Date of Issue: August 2016

Affected Publication: API Specification 6A, *Specification for Wellhead and Christmas Tree Equipment*, Twentieth Edition, October 2010

ERRATA 10

Page 198, Table 87 (continued):

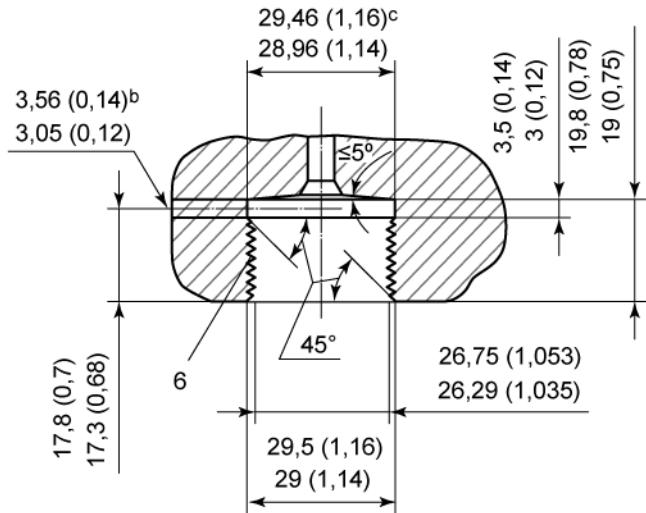
The first two columns, for **13,8 MPa**, **20,7 MPa**, and **34,5 MPa**, should read as follows:

Nominal size and bore	
Vertical B_V +0,8 0	Outlet B_0 +0,8 0
13,8 MPa	
52	52
65	52
65	65
79	52
79	65
79	79
103	52
103	65
103	79
103	103
20,7 MPa	
79	52
79	65
79	79
103	52
103	65
103	79
103	103
34,5 MPa	
52	52
65	52
65	65
79	52
79	65
79	79
103	52
103	65
103	79
103	103
130	52
130	65
130	79
130	103
130	130
